RESPONSE TO SUBMISSIONS REPORT

Modification for New Public School in Mulgoa Rise - SSD 11070211-
Mod-1

12 August 2022

Figure 3 - Extract from Figure 2 of Updated Flood and Stormwater Management Advice Report

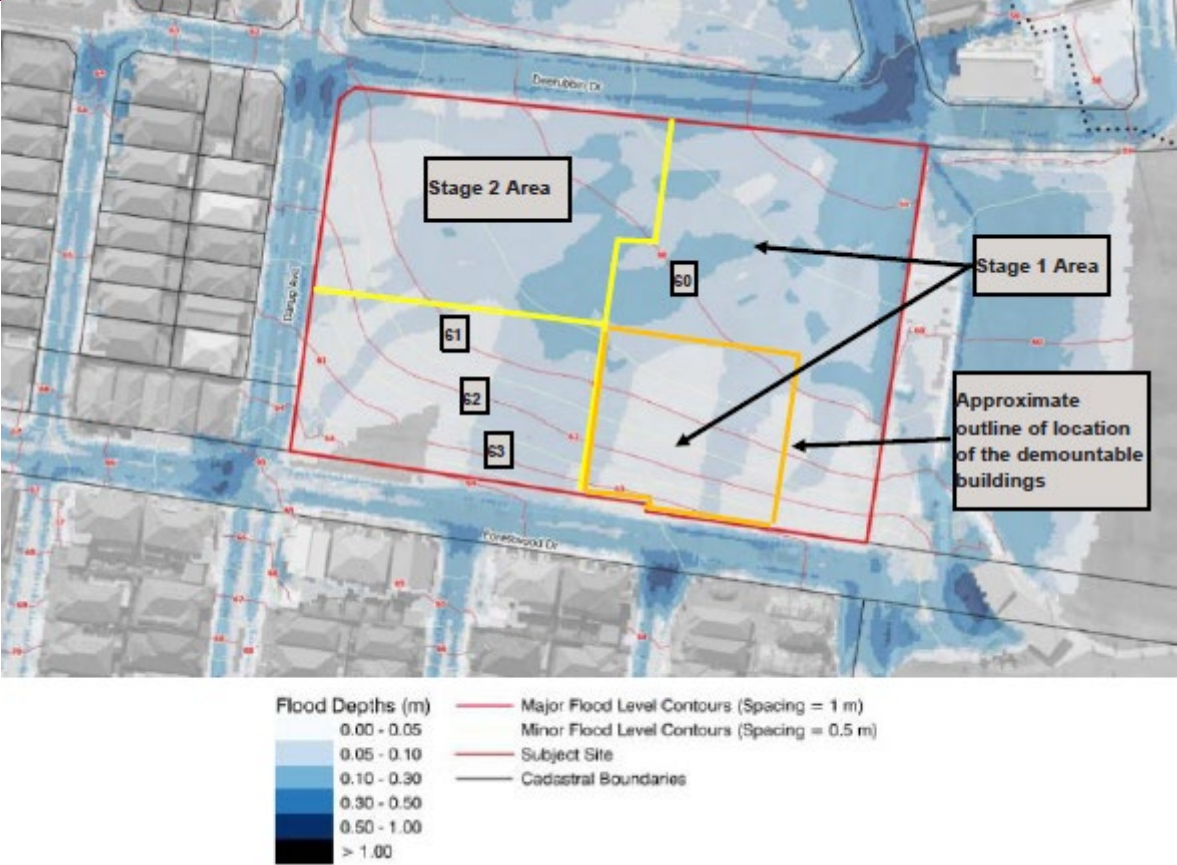
Assess flood behaviour on-site and in the surrounding areas post-development of the proposed temporary buildings, for both the PMF and 1% Annual Exceedance Probability events. Clearly state whether the proposed temporary buildings would result in any additional flooding to surrounding properties.

The design and minimum habitable floor levels of the buildings as submitted with the Modification Application are based upon the Updated Flood and Stormwater Management Advice Report. Any of the proposed buildings that lie within the PMF and 1% AEP flood event extent will be constructed on piers and therefore the temporary buildings will not affect the flood behaviour onsite or the surrounding areas due to the free flow underneath.

Figure 4 - Extract from setback plan showing proposed tree removal along Forestwood Drive.

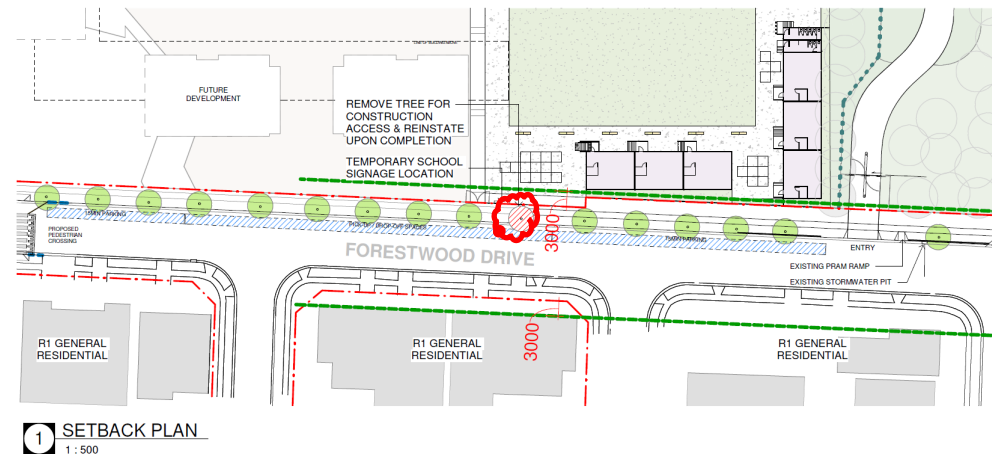
The Department has reviewed the Modification Report and advice provided by EHG and notes that one existing tree on Forestwood Drive is proposed to be removed. It is not clear on the landscaping plans submitted which tree will be removed. Please confirm and provide revised plans detailing:

- which existing street tree will be removed on Forestwood Drive or otherwise;
- the species of any tree proposed to be removed; and
- if proposed, the location, species, height and age of the replacement tree.

Figure 4 provided below shows the existing street tree to be removed. The species is confirmed to be that of a Chinese Elm. Whilst it is considered appropriate to maintain a consistent streetscape (and therefore replace the street tree with the same species), the Proponent is prepared to accept a condition which requires any replacement tree to be a native species of similar height and age to the original tree. Indicative species may include *Angophora costata*, *Eucalyptus punctata*, *Eucalyptus tereticornis* depending on availability, with an indicative pot size of 100L.

Figure 5 - Extract from setback plan, Forestwood Drive.

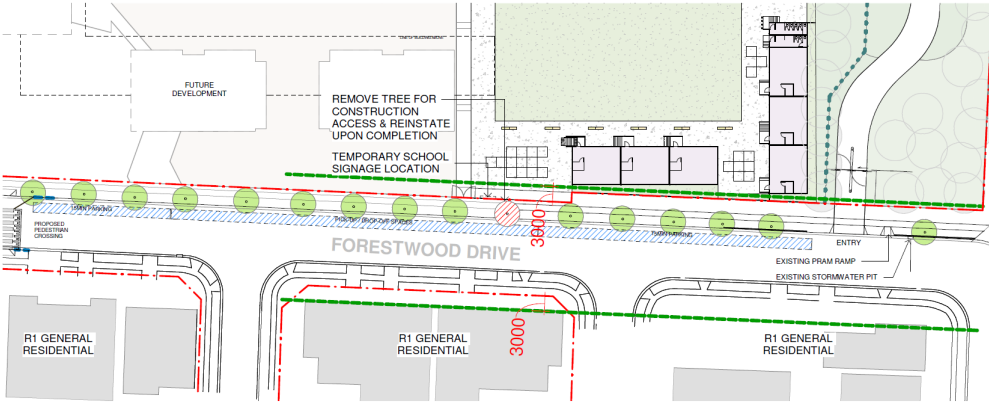
The proposed setbacks of the demountable buildings from Forestwood Drive have not been nominated on the plans. The plans should be updated in this regard and consideration should be given to providing for street setbacks which, as far as possible based on available space, are characteristic of the dwelling setbacks on the southern side of Forestwood Drive.

Comment/Issue	Response
Planning considerations	
The proposed setbacks of the demountable buildings from Forestwood Drive have not been nominated on the plans. The plans should be updated in this regard and consideration should be given to providing for street setbacks which, as far as possible based on available space, are characteristic of the dwelling setbacks on the southern side of Forestwood Drive.	<p>A plan showing the built form setback lines along Forestwood Drive is provided in Appendix C and an extract from it is provided in Figure 5 below.</p> <p>At the closest point to the southern boundary elements of the temporary school structures will be approximately 1.5 metres from the 2100mm high security fence. At this location it is noted that the boundary with Forestwood Drive is indented by 2 metres possibly reflecting the historic 20 metre road reserve against that of Forestwood Drive to the west of the Hassall Way intersection which has an 18 metre road reserve. Having regard for the boundary anomaly and the fact that residential development on the southern side is set back at least 3 metres from the road reserve, as illustrated in Appendix C and Figure 3, the distance of the temporary school structures from the southern boundary is considered appropriate based on the available space and the temporary nature of the development.</p>  <p>1 SETBACK PLAN 1 : 500</p>

Figure 7 - Extract from provided plan of electrical network along Darug Avenue.

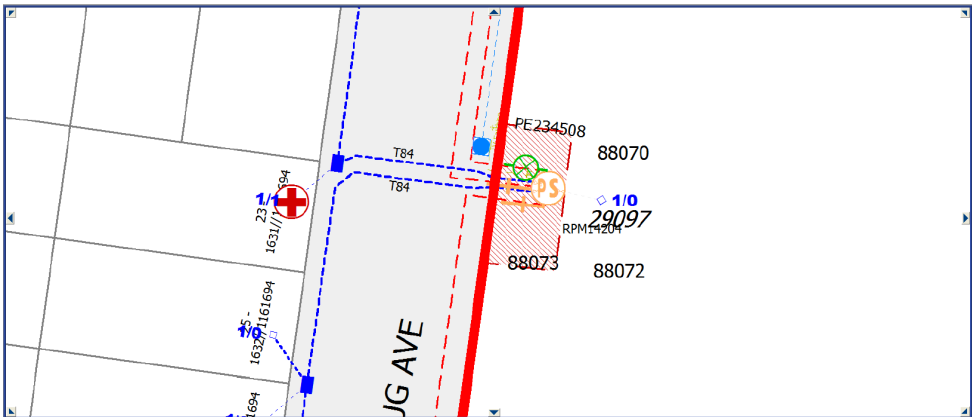
Comment/Issue	Response
Servicing considerations	
The temporary school / Stage 1 is located to the south-eastern corner of the site to the Forestwood Road frontage which currently has limited existing electricity infrastructure consisting of a streetlight column to the road verge. Based on the foregoing Endeavour Energy has no further recommendations or comments regarding the proposed development.	Noted.
The below updated Site Plan from Endeavour Energy's G/Net Master Facility Model shows padmount substation no. 29097 is now 'Proposed removed' indicated by the orange colouring.	Figure 7 below demonstrates the proposed removed padmount substation, which has been noted.

Figure 4: Proposed Development and PMF Flood Extent.

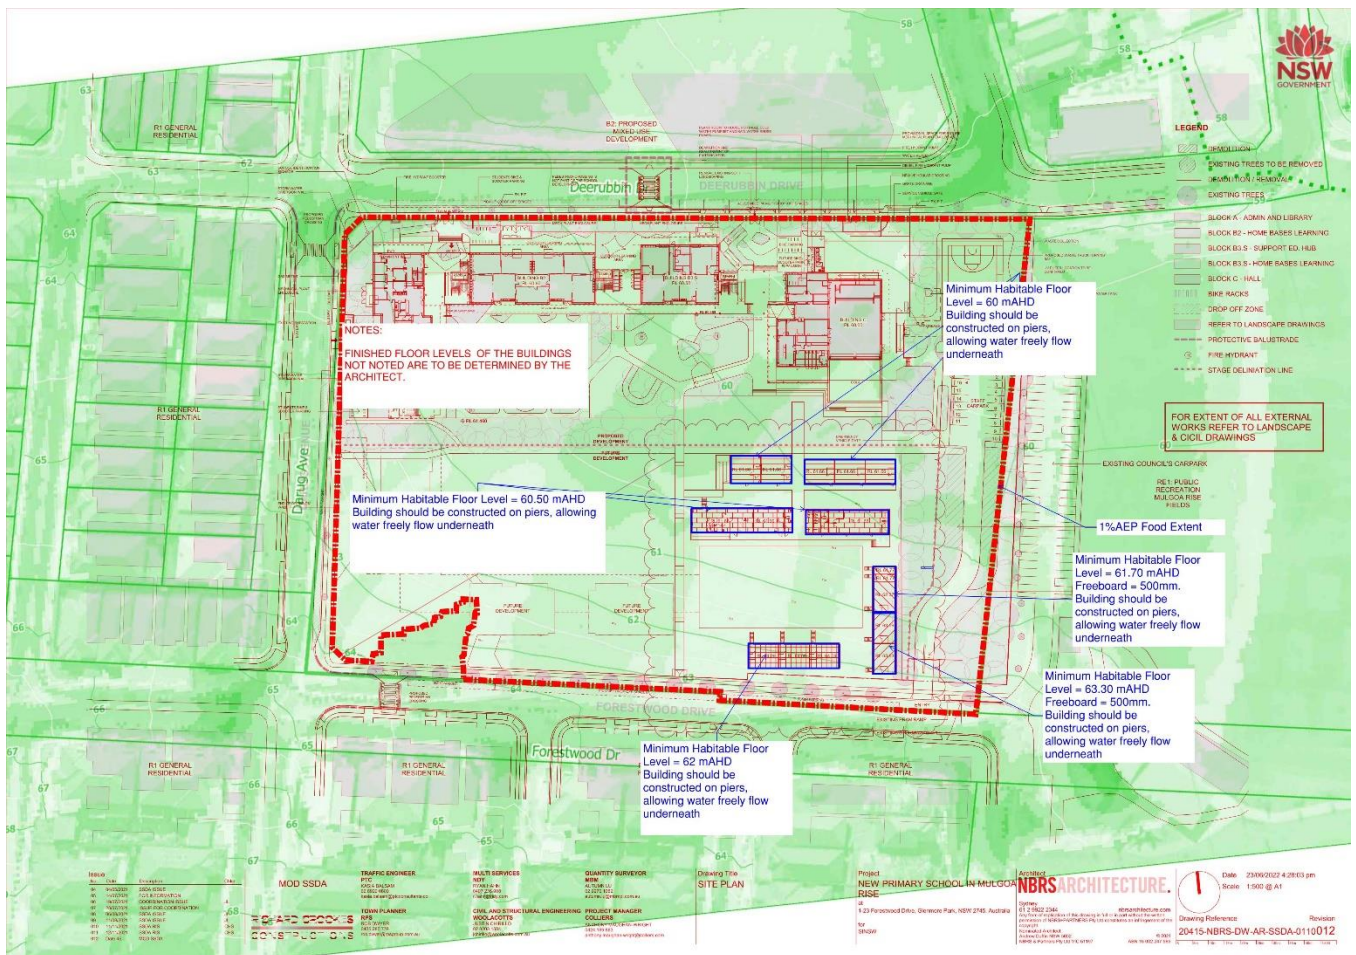
- assess the extent of overland flooding during a probable maximum flood event (PMF) and the subsequent impact on any temporary buildings proposed as part of this Modification Application;
- assess flood behaviour on-site and in the surrounding areas post-development of the proposed temporary buildings, for both the PMF and 1% Annual Exceedance Probability events. Clearly state whether the proposed temporary buildings would result in any additional flooding to surrounding properties; and
- provide details as to which Australian Standards and/or guidelines, that any buildings impacted by overland flooding will be constructed to, to withstand overland flooding and minimise the risk of death or injury to occupants and damage to property.

- The temporary buildings are inundated during the PMF storm events and should be raised on piers. The recommended minimum habitable for each building was detailed in the figure 4.
